ANACORTES PLANNING COMMISSION

Anacortes Planning Commission Recorded Motion Regarding Amendments to the Development Regulations and the Official Zoning Map

The following table lists the most major changes in the 3rd draft the Anacortes Development Regulations between publication on December 18, 2018 and April 3, 2019 resulting from internal staff discussion, legal review, Planning Commission direction, and response to public comments.

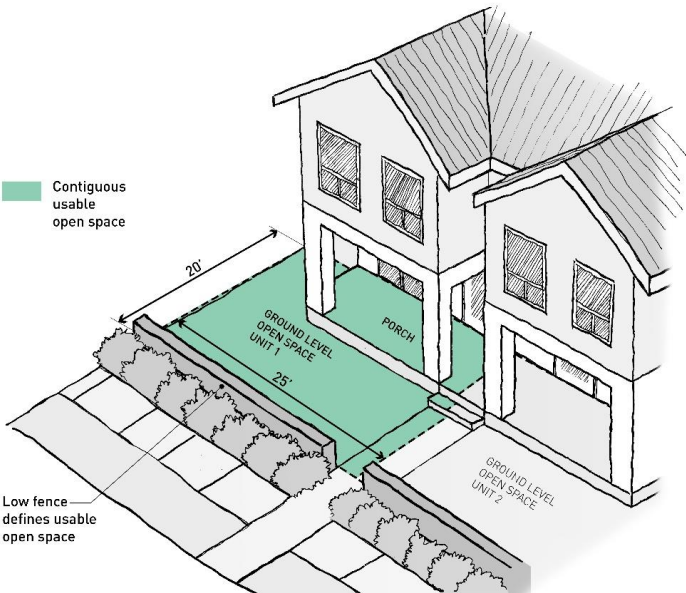
AMC Reference	Recommended Change
19.43.010(E)(2) and (F)(2), Triplexes and duplexes	<i>Updated open space design standard resulting from several public comments and internal/staff discussion.</i> b. See AMC 19.53.030 for general driveway and access easement standards. Separate driveways are permitted for each unit provided each driveway is limited to 12 feet in width and meets driveway separation standards in AMC 19.53.030(D). c. Standards for minimum useable open space. i. All new duplex units must provide a contiguous open space with a minimum dimension of 15 feet on all sides. ii. The minimum collective size of usable open space is 10 percent of the lot area. For example, an 8,000 square foot lot would require at least 800 square feet of usable open space, which could include separate 20 feet by 20 feet usable open spaces for each unit. iii. Where the usable open space is configured within the street setback, the open space must be defined with a fence or wall (meeting the standards of AMC Chapter 19.66). See Figure 19.43.010(E)(2)(d) for an example. iv. Covered but unenclosed decks and porches may be used as a part of the usable open space provided they are a part of a space that meets the standards herein. Figure 19.43.010 (E)(2)(c) Example of integrating a duplex's minimum usable open space into the street setback.
